HISTORIC LANDMARK COMMISSION Application for a Certificate of Appropriateness August 23, 2021 HR-2021-115716 Kohn House 5312 Shoal Creek Blvd.

Construct a low fence at the front property line and a detached 2-car garage behind the house at a pending landmark.

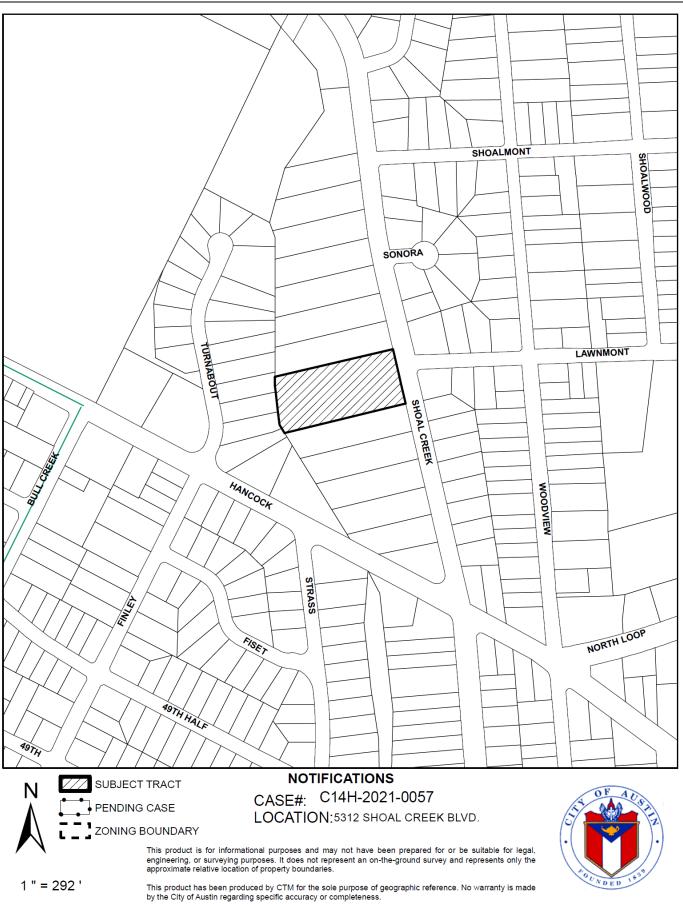
During the prior review of site modifications in April 2021, staff found the proposal for a front-yard fence out of character with the open lawns of the Shoalmont Addition and did not recommend approval. The applicant has since provided additional information in support of a fence at this location. Mature oak trees are a character-defining feature of the site and partially screen the house from view, but some major trees have been removed. Although replanting is planned, it will take time to recover the full canopy. Plantings along the open mesh fence will provide similar vegetative screening in the meantime. At 36", the fence will be 1' lower than the height recommended in the Historic Design Standards and will not block the view of the house. In terms of compatibility of design, the fence will have a rustic feel appropriate to this large estate. Limestone piers will have a random ashlar pattern reminiscent of the stone on the house, differentiated by the planar surface of the sawn face and parged joints in contrast with the rough face and recessed joints of the house.

Staff revises the prior recommendation to find that the proposed fence meets the applicable standards.
